# 21-019ARB-INF – 110-112 S. RIVERVIEW STREET

Informal review for the demolition of an existing two-family home and construction of an approximately 2,900-square-foot single-family home located on a 0.589-acre site in Historic Dublin.

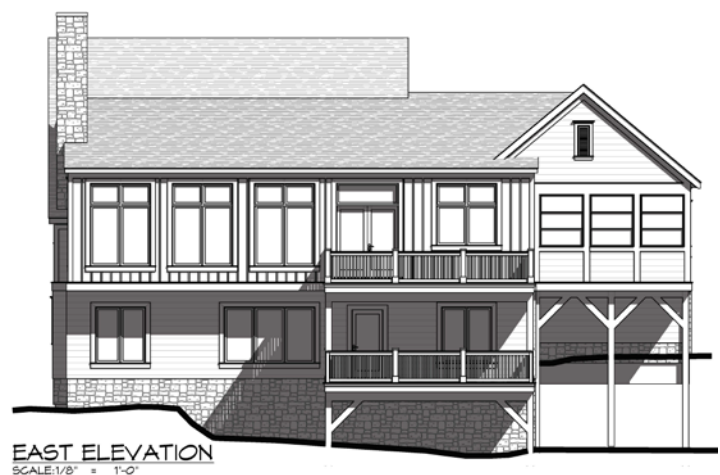
The north elevation contains the front gable form of the garage, with the top of the side gable form of the main structure visible. This elevation details the significant grade change west to east on the site. The north elevation is split between two levels. The street level contains horizontal siding along the two-car garage and extends into the side elevation of the sunroom to the rear of the home. The lower level contains a stone foundation moving into the supports for the sunroom. Behind the supports is the lower level of the home which is clad in horizontal siding and varying levels of stone foundation. The north elevation includes a two-over-three window for the garage and three-over-one windows for the sunroom. The stone-clad chimney is visible from this elevation.

Preservation Designs recommended the sunroom windows be changed to either a sash or casement window to be more compatible with other proposed windows on the home, along with choosing a separate material for the sunroom to separate it from the main structure..

The south elevation contains the side gable form of the main structure, with the top of the front gable form of the garage visible on the elevation. This elevation also presents the significant grade change as the site carries from west to east. The steeper side gable area of the elevation is clad in horizontal siding, while the additional side gable area is clad in board and batten siding. The elevation also features a stone-clad chimney towards the rear of the home. The stone foundation is reduced and steps down toward the rear of the home. The south elevation includes a combination of two-over-three windows, a two-over-two window, and a single-hung window. The rear of street level elevation is cantilevered over the rear of the home.

Preservation Designs recommends creating a uniform foundation line along the elevations of the home. The consultant recommends removing the cantilever support of the main structure and incorporating it into the main house with a solid foundation. In addition, the consultant recommends this area should have the same horizontal siding of the main house and not vertical board and batten, and the stone chimney should be extended to reach grade. The consultant also notes that the lower level window will need to ensure it meets egress requirements. .
